Addendum No. 2

PROJECT: 1800107-Churchill HS Softball Field **INITIATOR:** Anna Backus
DATE: July 11, 2018 **GC:** TBD
BID ISSUE NO.: 2 **OWNER:** Eugene School District 4J

4J School District
CHURCHILL HIGH SCHOOL SOFTBALL FIELD
GRADING PLAN

SHEET NO.	
C2.0	
SHEET 2 OF 4	
RECORD NO.	1800107

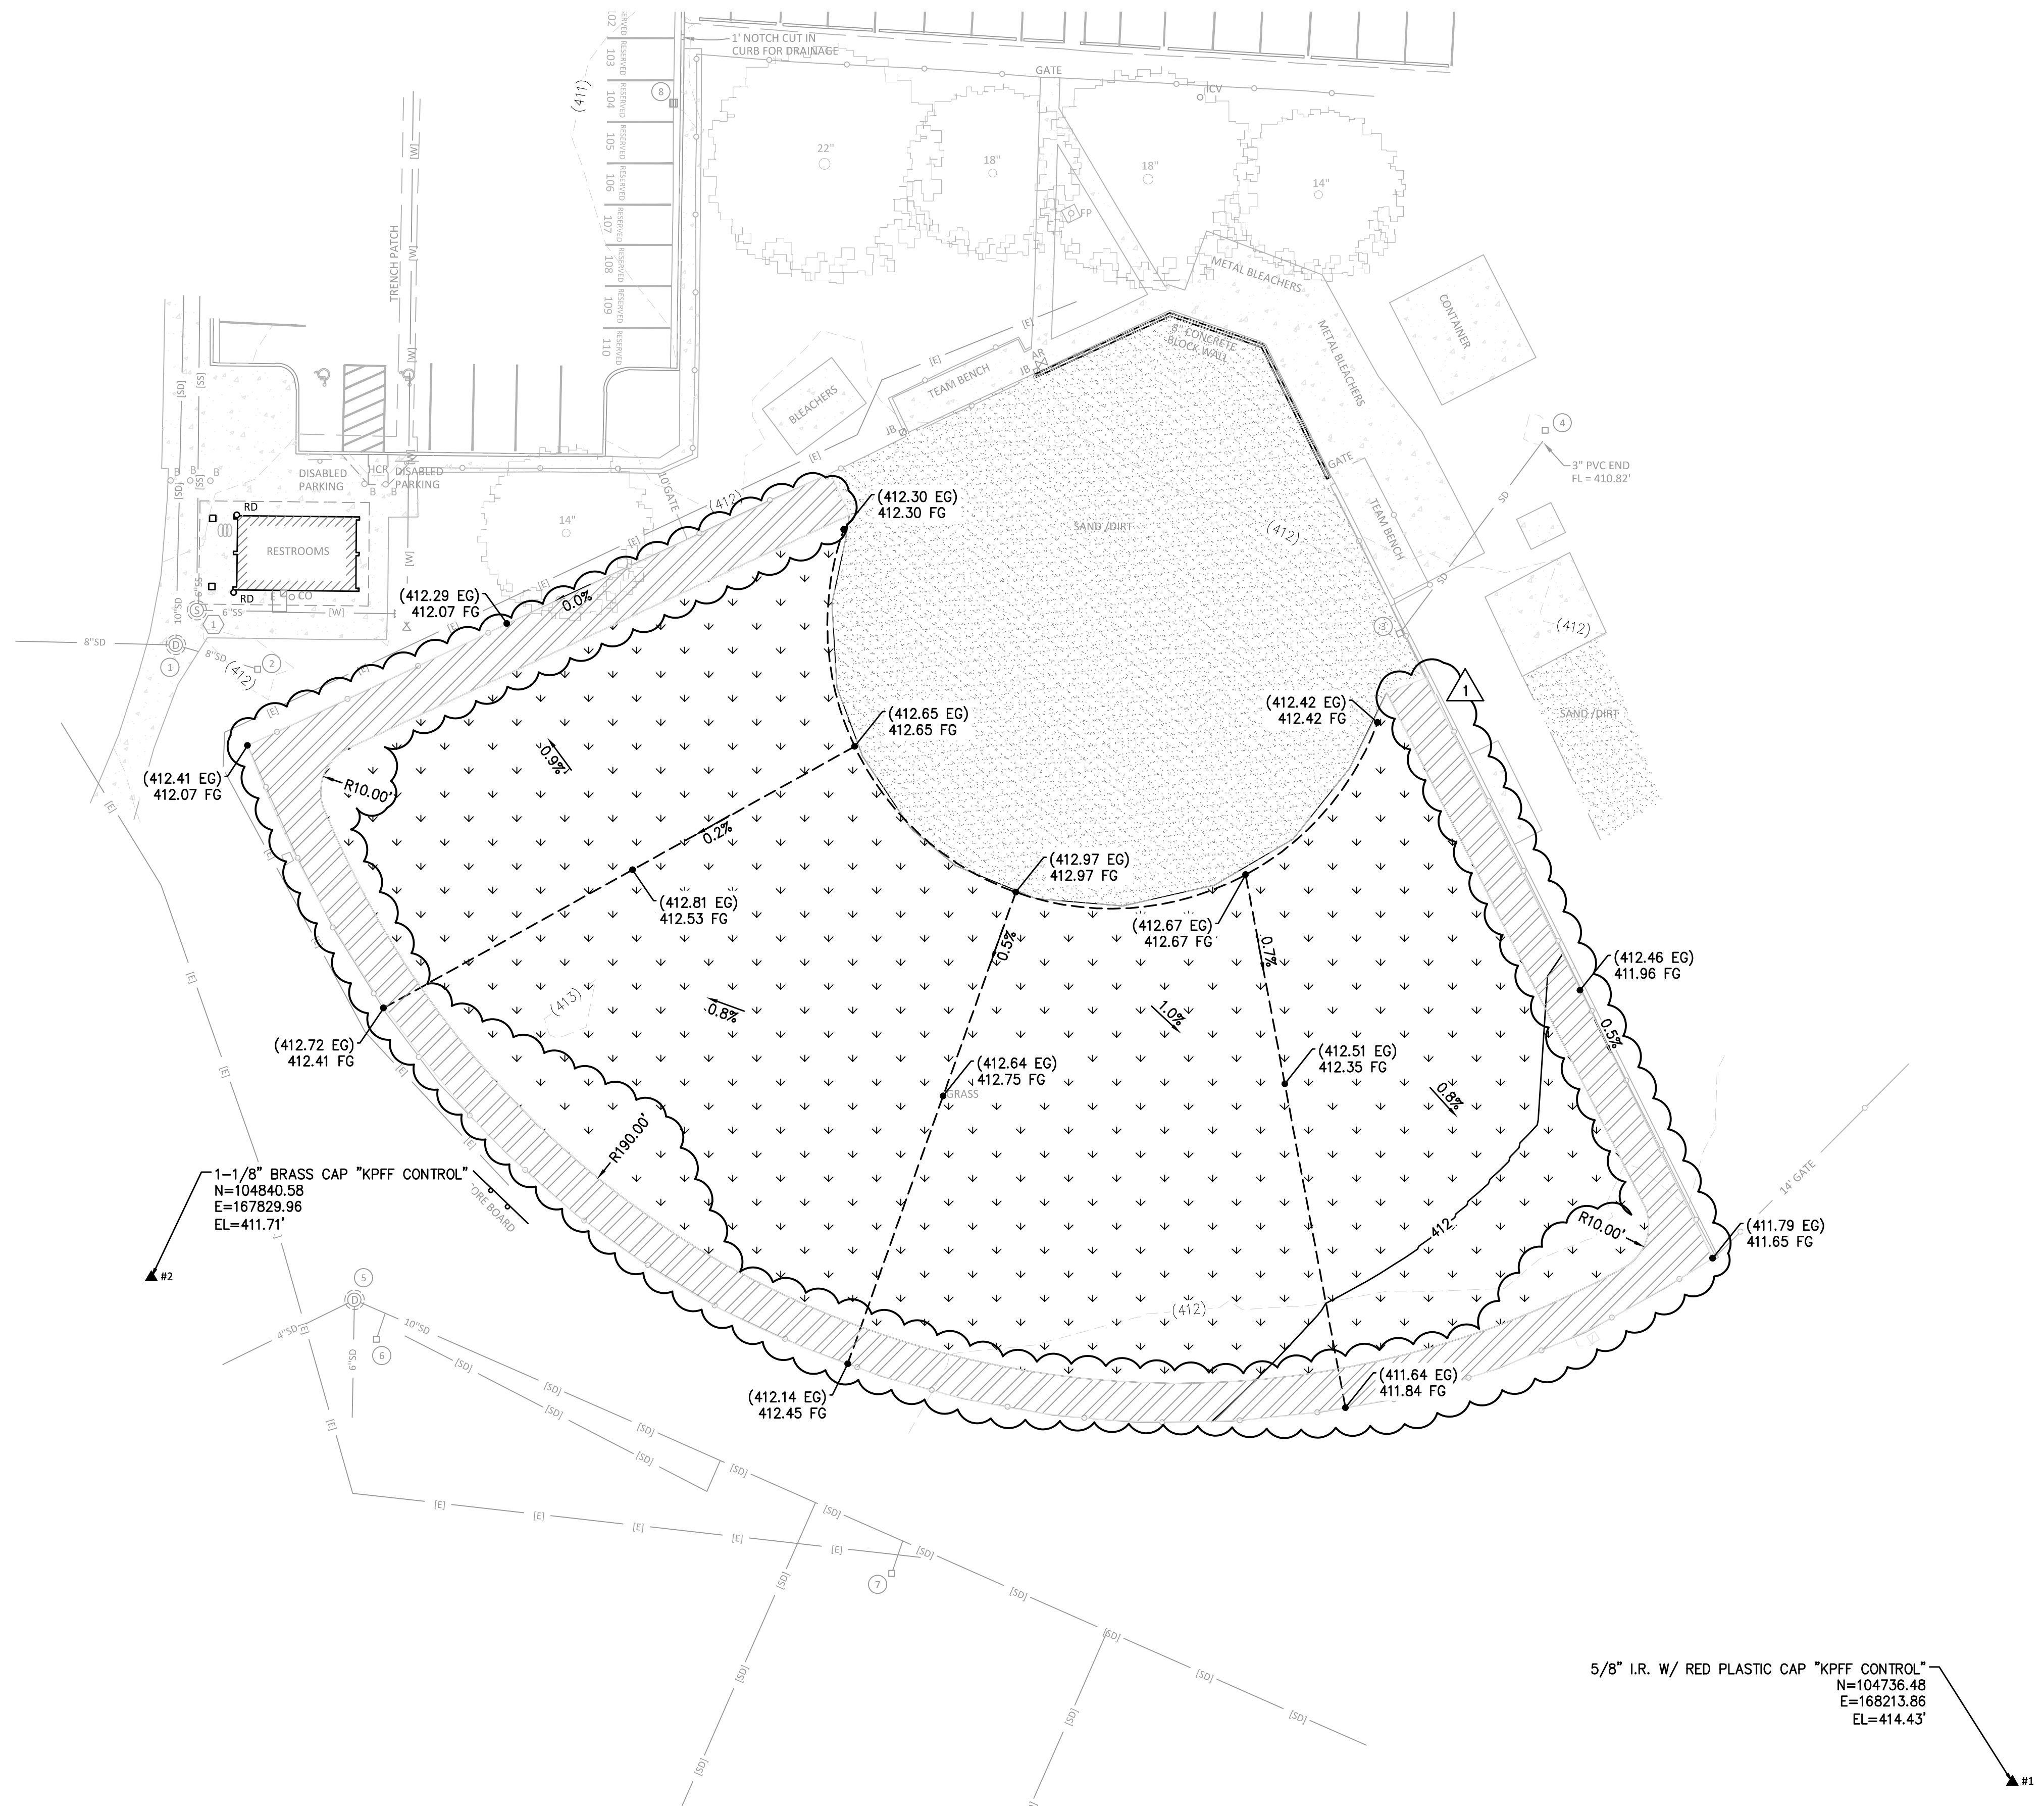
ITEM NUMBER	SPEC OR DRAWING NUMBER	LOCATION AND DESCRIPTION OF CHANGE
1	C2.0	Replace warning track.
2	1500 – Temporary Facilities and Controls	Delete references to Field Offices, including sections 2.2-A through 2.2-B.

SYMBOL	DESCRIPTION	DETAIL REF.
	DRAINAGE FLOW DIRECTION	
	GRADE BREAK	
	EX. CONTOUR MINOR	
	EX. CONTOUR MAJOR	
	CONTOUR MINOR (FG)	
	CONTOUR MAJOR (FG)	
	CONVEYANCE SWALE	
	NEW SOIL & SEEDING	2/C4.0
	REPLACE WARNING TRACK. INSTALL 4" RED CINDER BUTTE SAND OR APPROVED EQUAL OVER COMPACTED SUBGRADE.
